CHANGE ORDER

<input checked="" type="checkbox"/> ORDERED BY ENGINEER UNDER SECTION 1-04.4 OF THE STANDARD SPECIFICATIONS. <input type="checkbox"/> CHANGE PROPOSED BY CONTRACTOR	PROJECT IDENTIFICATION PROJECT NAME: 36 th Avenue W & 35 th Avenue W, 164 th St SW to SR 99 PROJECT NUMBER: RC1783, RC1784, RR6337, RR6342, UPI 06-0014 Fed Aid #: STBGUL-2585(001)
CONTRACTOR ENDORSEMENT: <div style="display: flex; justify-content: space-between;"> <div>SIGNATURE</div> <div>DATE</div> </div> <div style="border-top: 1px solid black; margin-top: 10px;">TITLE</div>	CONTRACTOR: Marshbank Construction, Inc. ADDRESS: PO Box 97 3304 Old Hartford Rd Lake Stevens, WA 98258

**CHANGE ORDER
NUMBER**

11

REFERENCE SHEET NO. DR05	SHEET 74 OF 163 SHEETS
---------------------------------------	------------------------------------

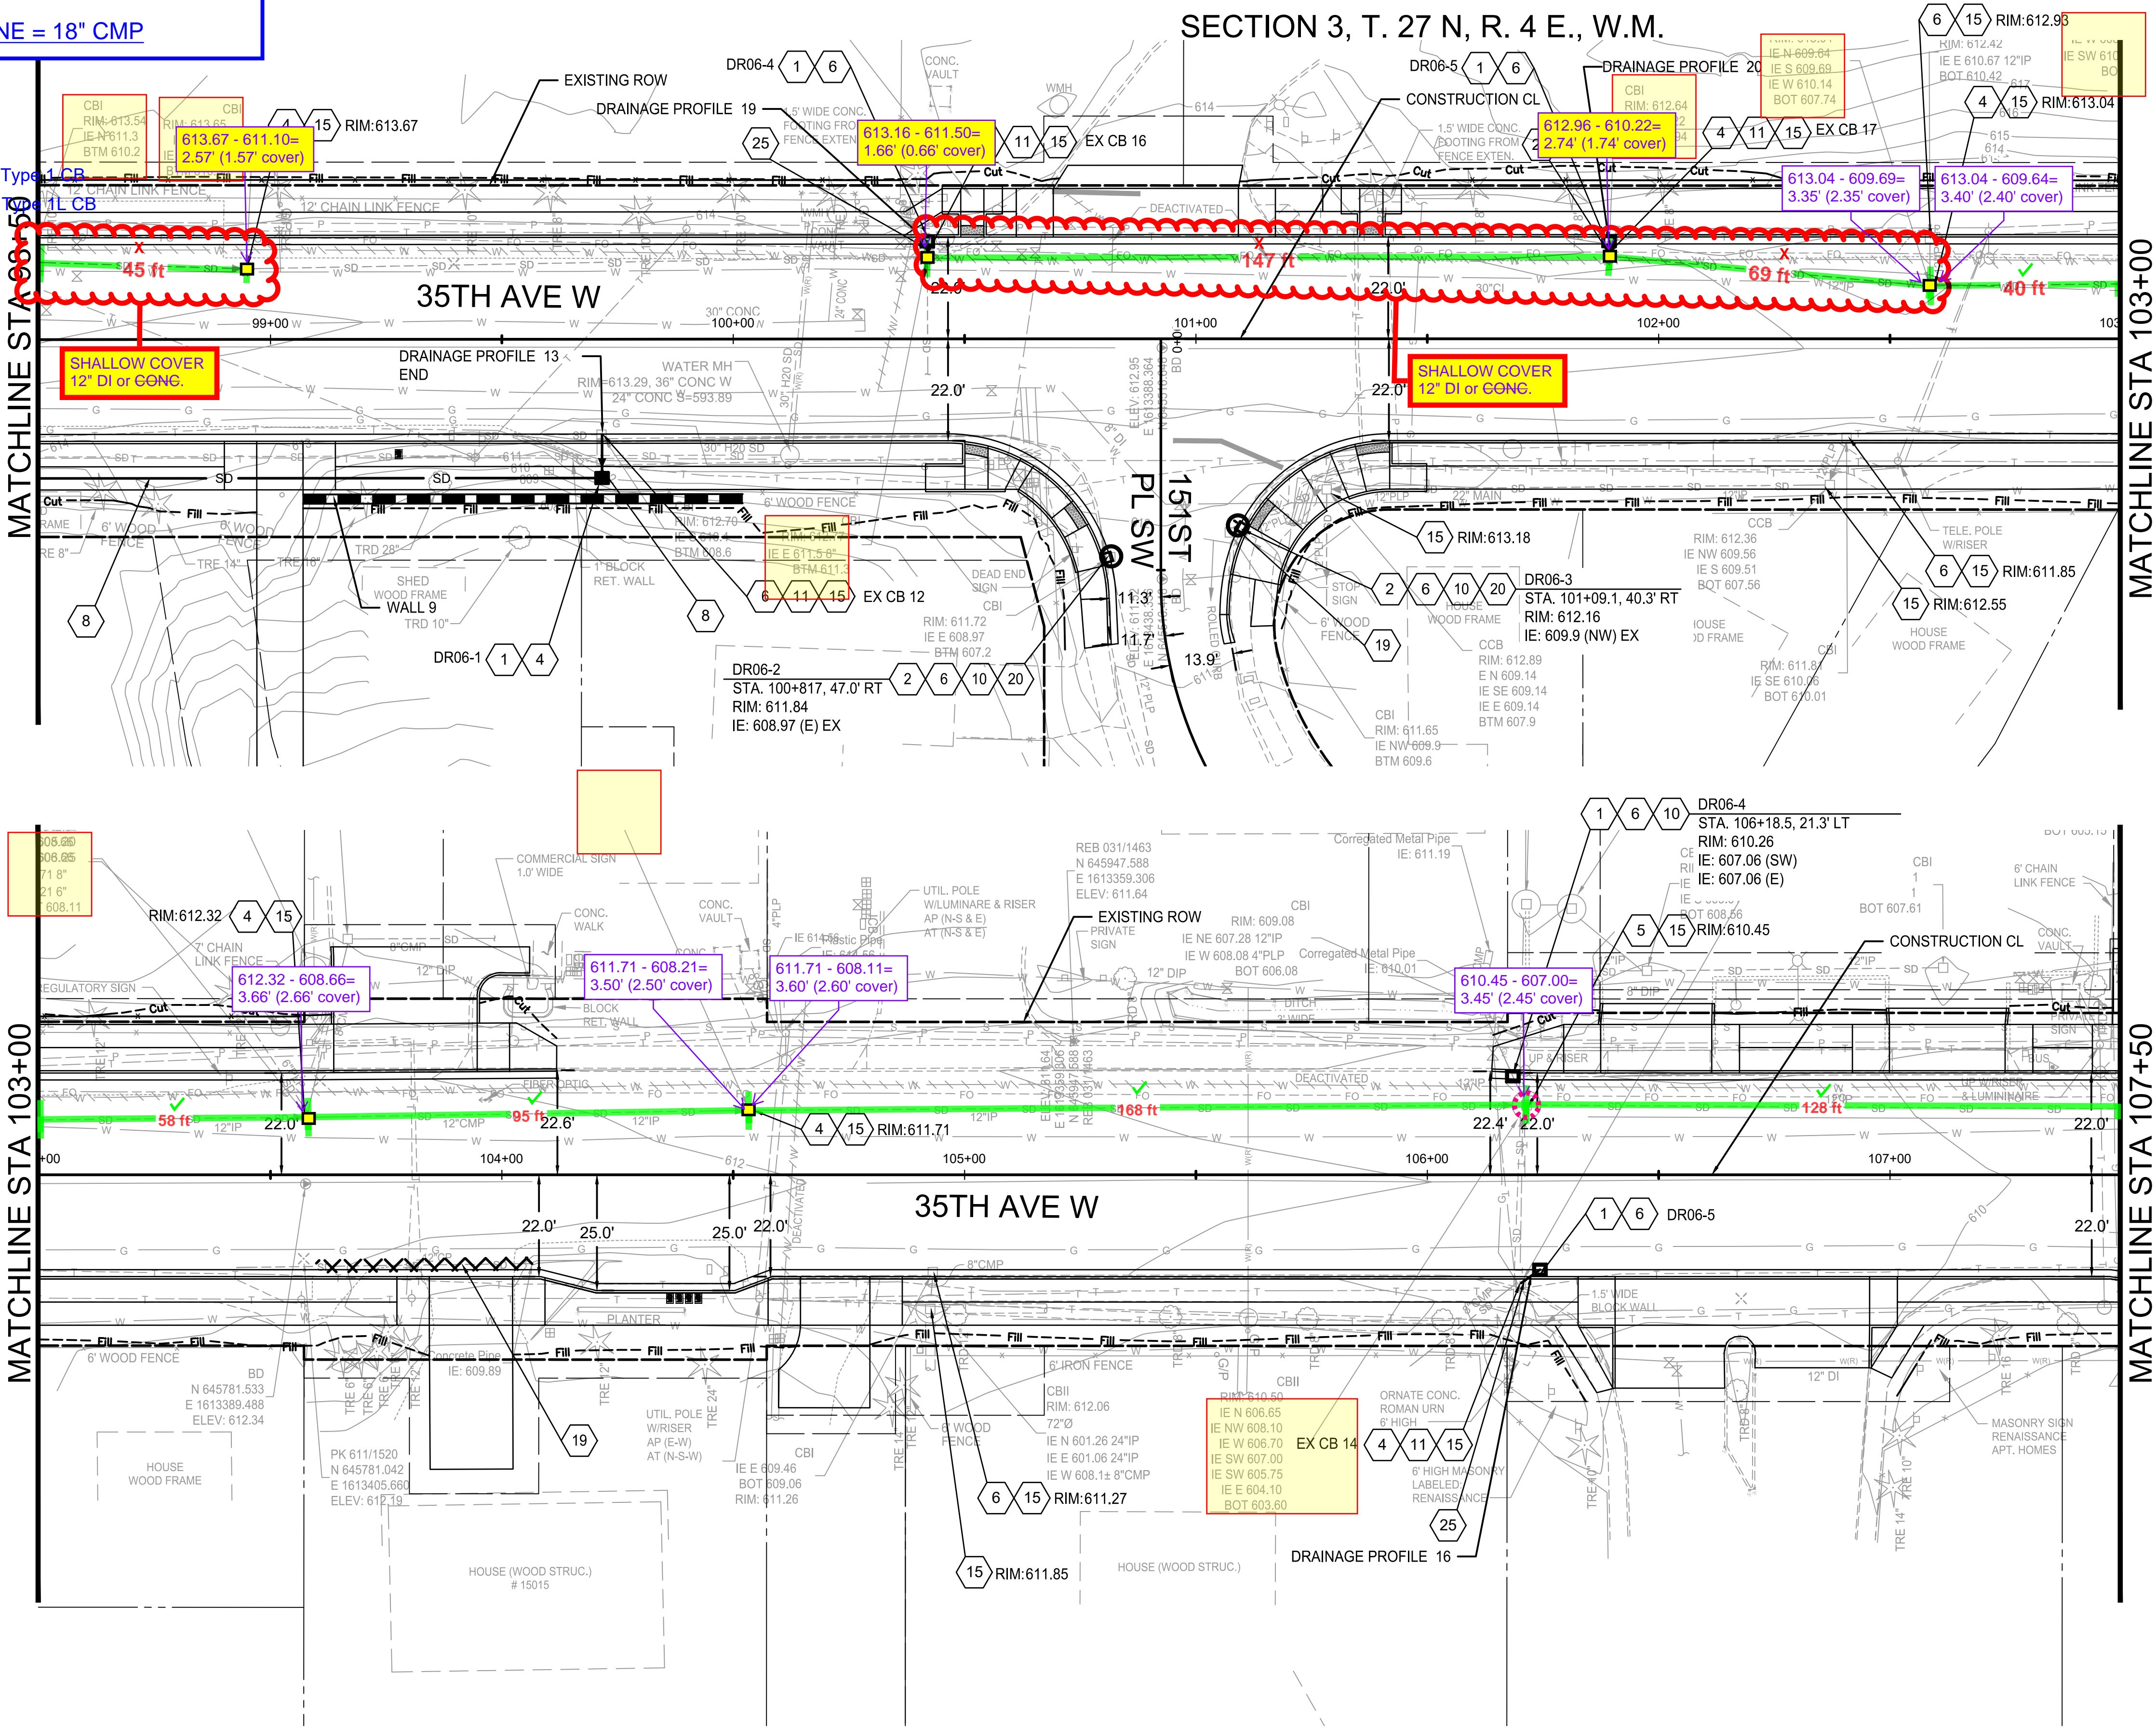
Existing BLUE LINE = 18" CMP

Ductile Replacement

**MAINTAIN EXISTING
ELEVATIONS FOR
REPLACEMENT PIPE
AND STRUCTURES**

Existing GREEN LINE = 12" CMP

This Change Order compensates the Contractor for removing and replacing existing storm drainage pipe runs and catch basins from Station 94+00 to 110+30 and as shown on revised plan sheets DR05 through DR07. Prior to removal, the Contractor shall record existing rim and invert at existing catch basins and reinstall the new storm drainage to match the existing invert elevations and pipe run slopes.

REFERENCE
SHEET NO.
DR06
SHEET
75
OF
163
SHEETS

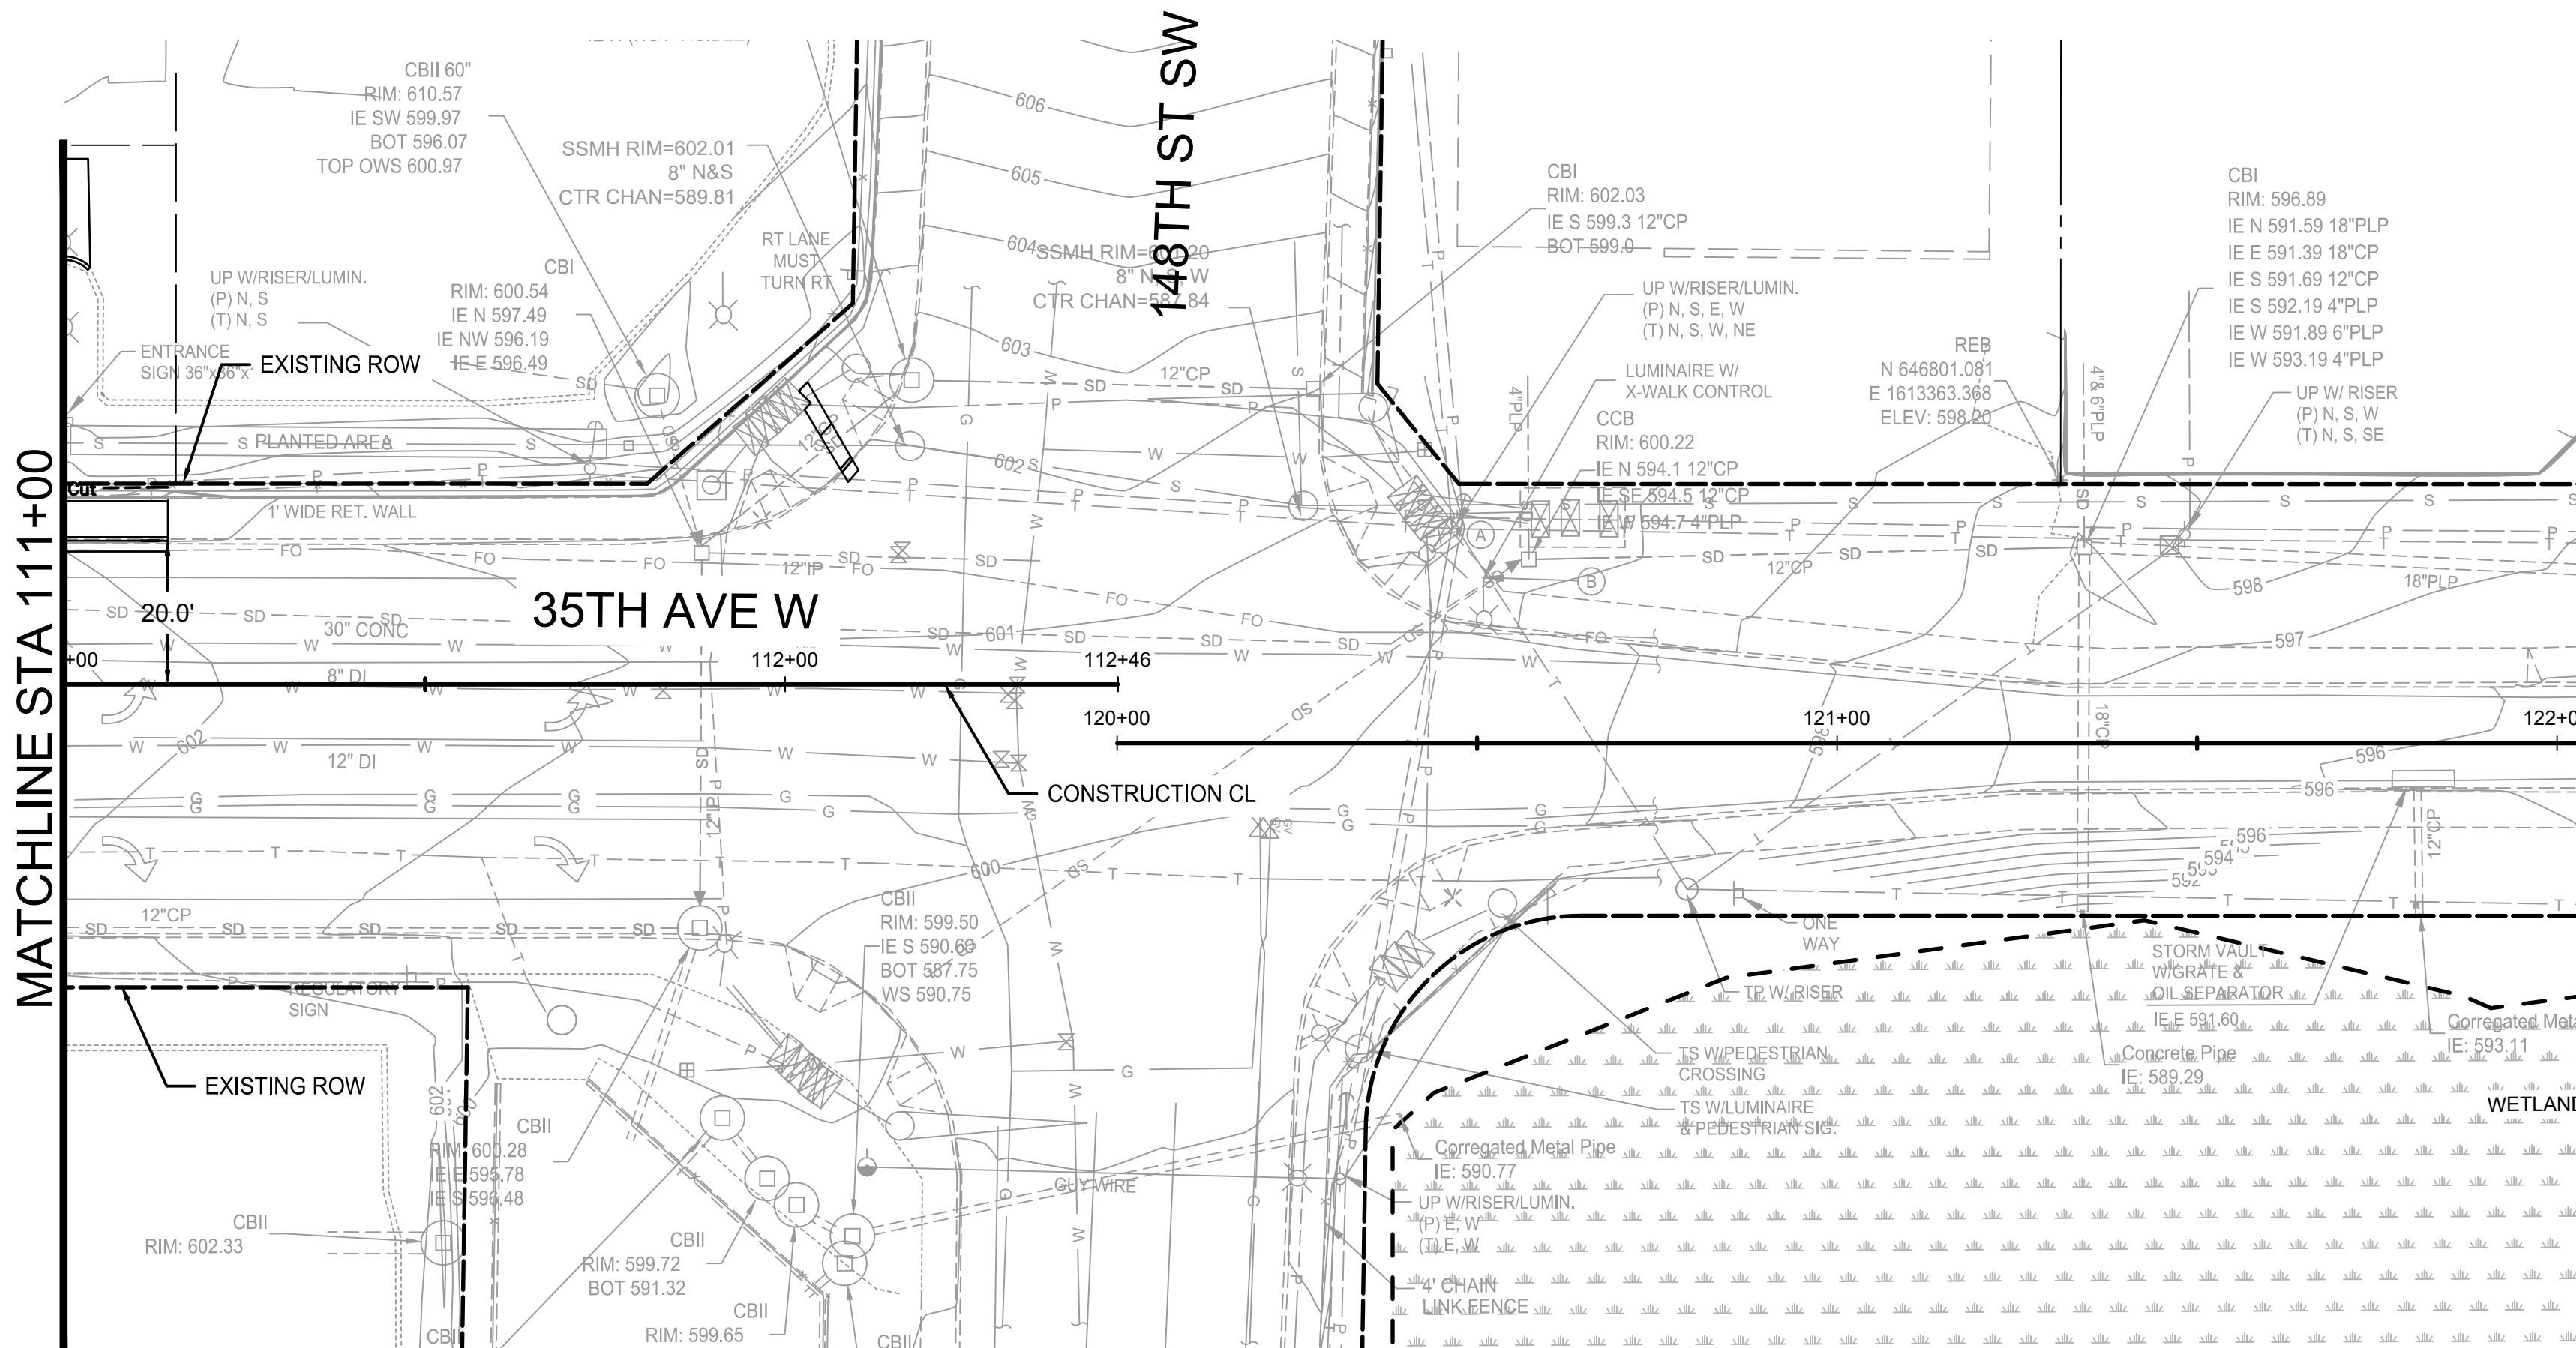
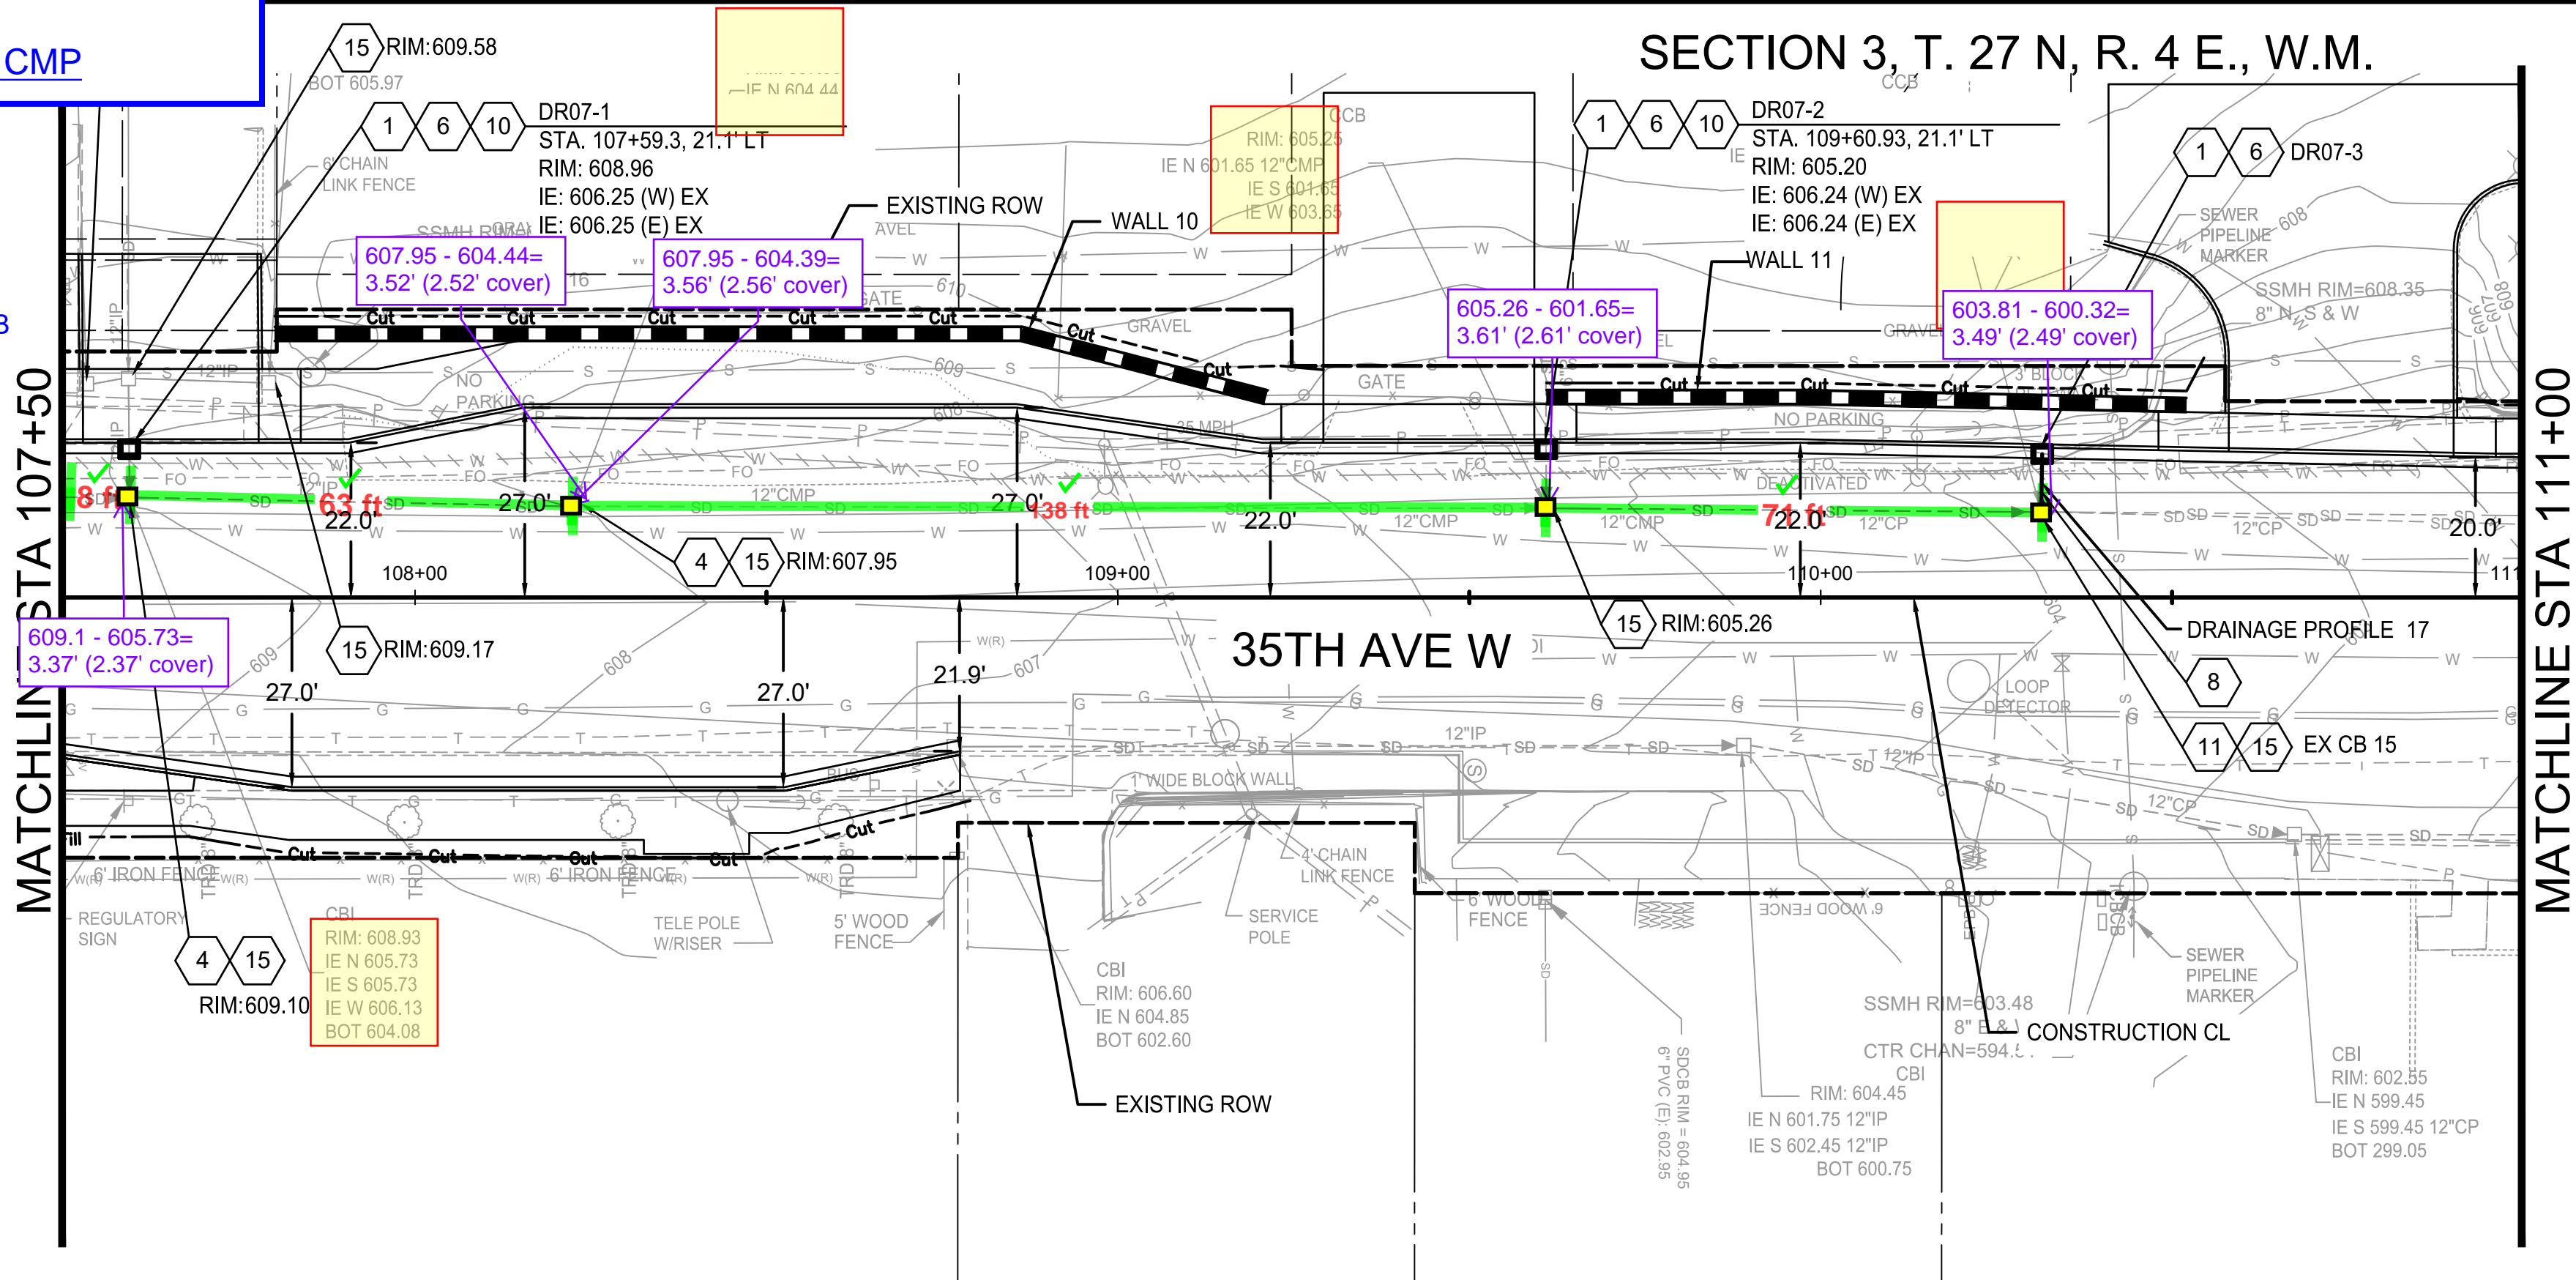
Existing BLUE LINE = 18" CMP

Ductile Replacement

= Replace - Existing Type 1 CB
= Replace - Existing Type 15 CB

MAINTAIN EXISTING ELEVATIONS FOR REPLACEMENT PIPE AND STRUCTURES
